Lime Down

Solar Park

Change Notification

Document Reference: EXAM/9.35

Change Application - Change 3.3

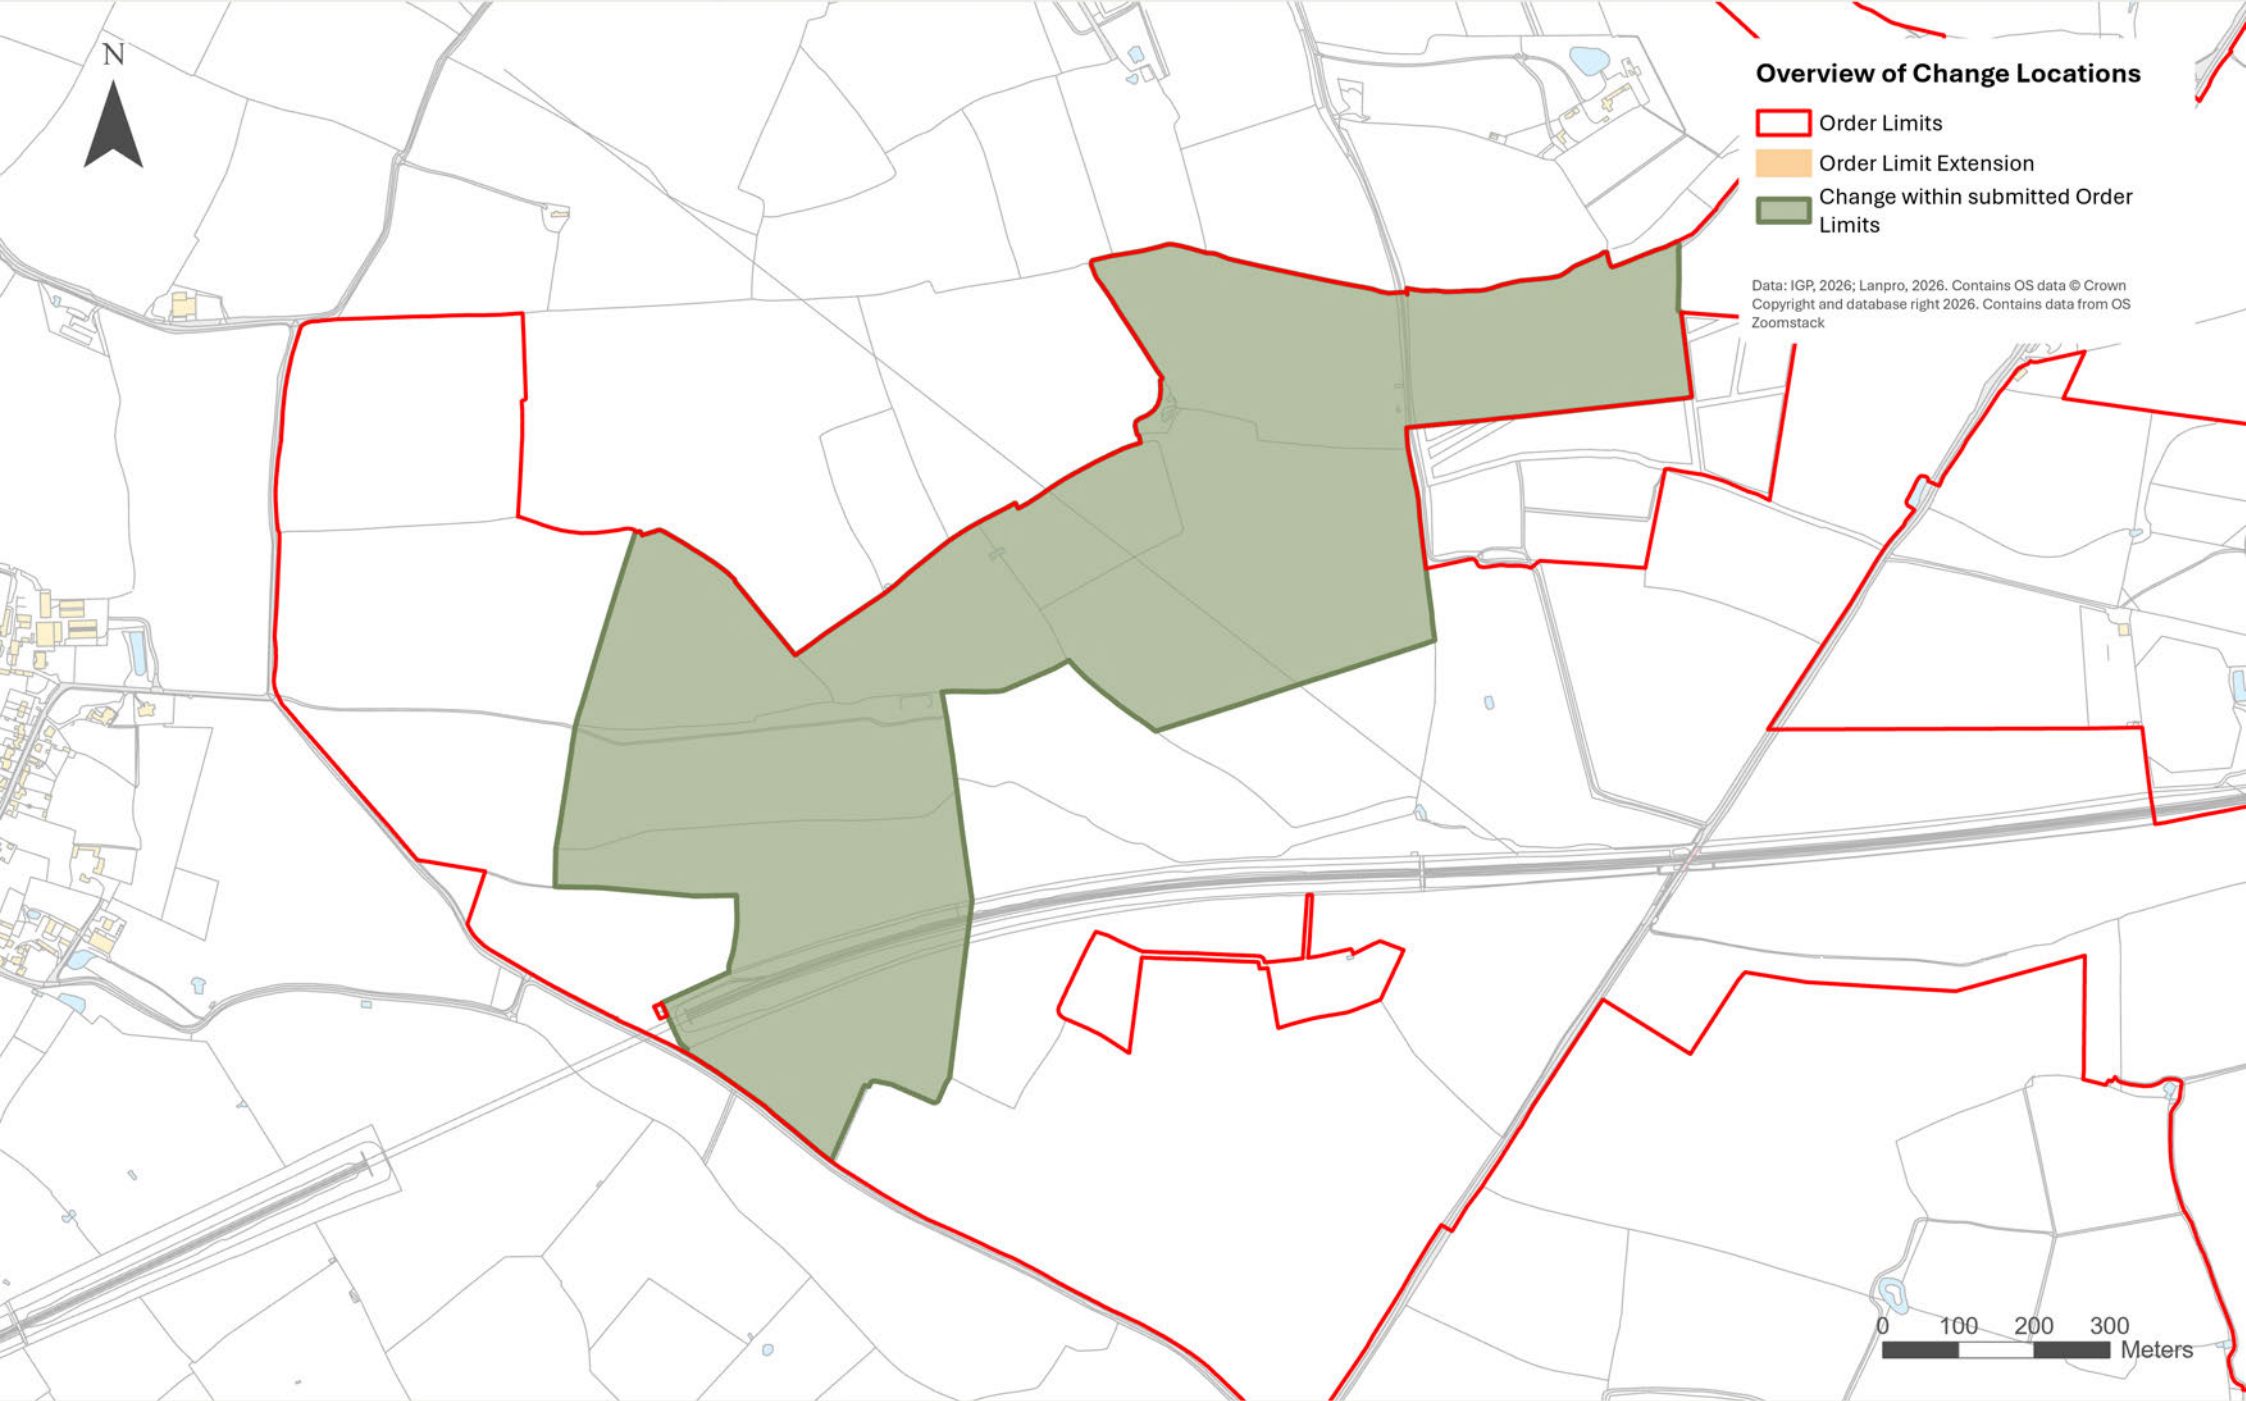
- 2.3.2 The area comprising Work Number 1(d) allows for electrical and communications cabling within the Solar PV Sites, and some areas of Work Number 1(d) already include areas of Work Number 5B, however incorporating Work Number 5B across the entire area of Work Number 1(d) allows for more flexibility at the detailed design stage in the routing of the interconnecting cables between the Conversion Units, 33 kV Sub-distribution Switch Rooms, 132 kV Substations, 400 kV Substation and the Solar PV Sites. The plan provided shows the additional area in Lime Down A (Change 3.1), Lime Down C (Change 3.2) and Lime Down E (Change 3.3) where the Applicant is seeking to include Work Number 5B in addition to Work Number 1(d).

- 2.3.3 All cabling will be underground, and subject to the parameters stated in the Design Principles and Parameters document **[EN010168/APP/7.4]** (Revision 3). There is no change to the extent of the Order Limits associated with Work Number 5B being included in addition to Work Number 1(d). Change 3 allows for the interconnecting cables to be laid in the same location as on-site cables, where possible, including the design flexibility to place both interconnecting cables and on-site cables into a single trench.

Change Application - Change 4

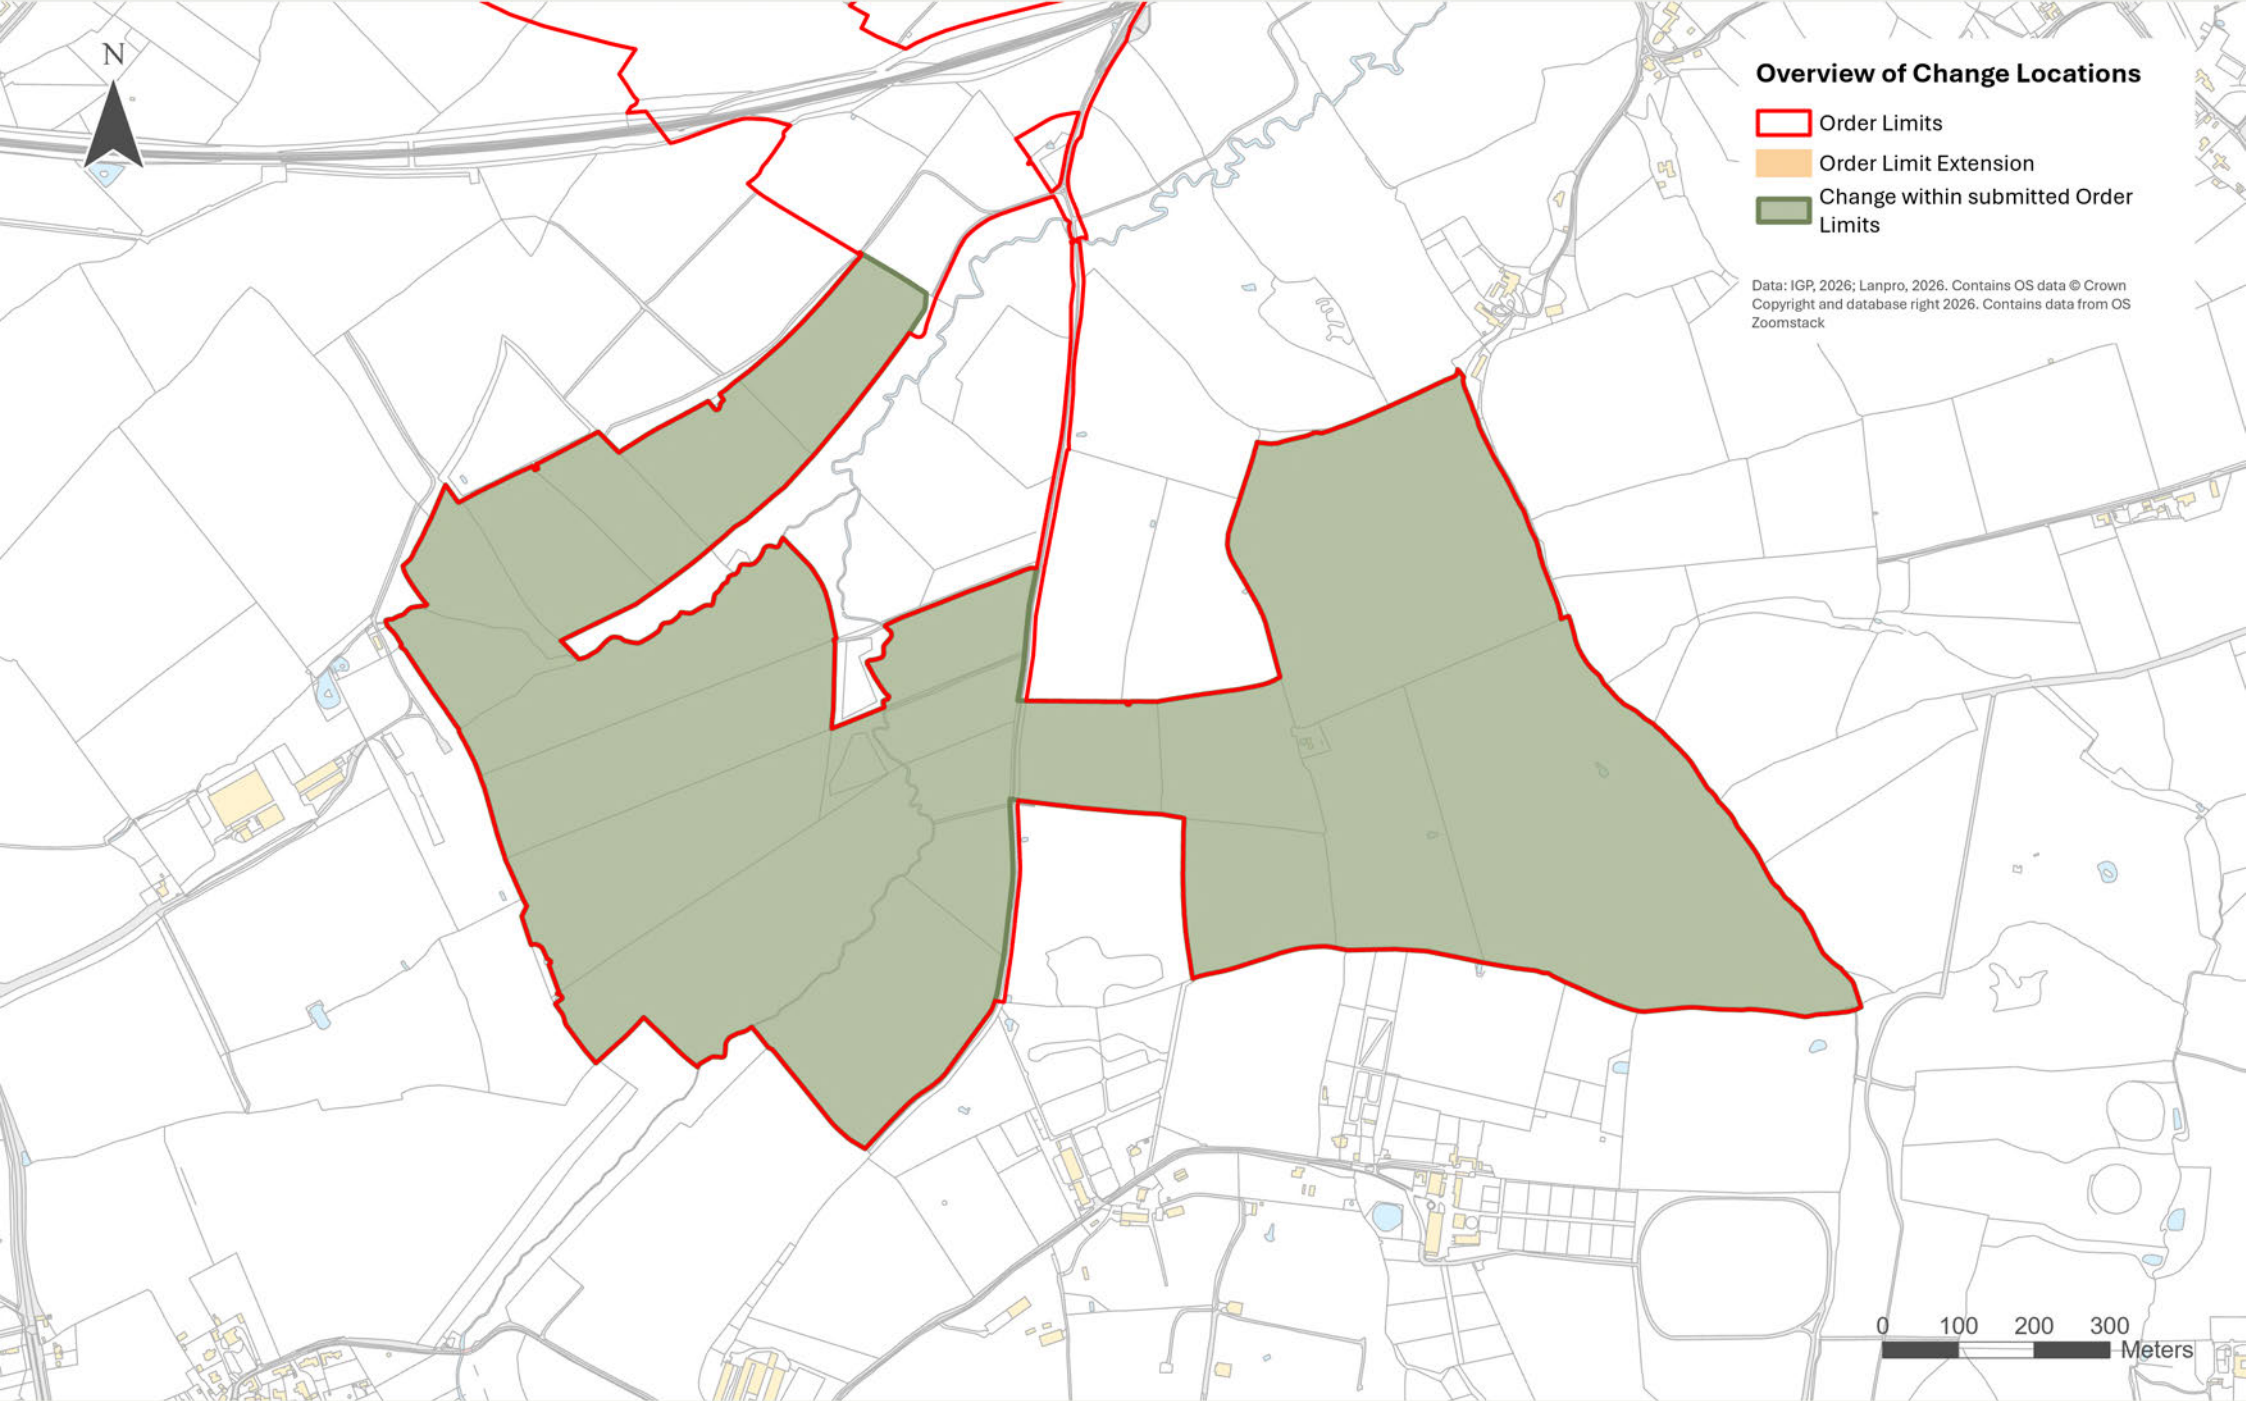
- 2.4.1 Change 4 comprises the removal of Solar PV Infrastructure from Field C9 to reflect ongoing engagement with the CNL Board related to the potential significant adverse visual effects for receptors located on Alderton Road.
- 2.4.2 The removal of the Solar PV Infrastructure in this location results in a reduction in significant effects for Alderton Road.
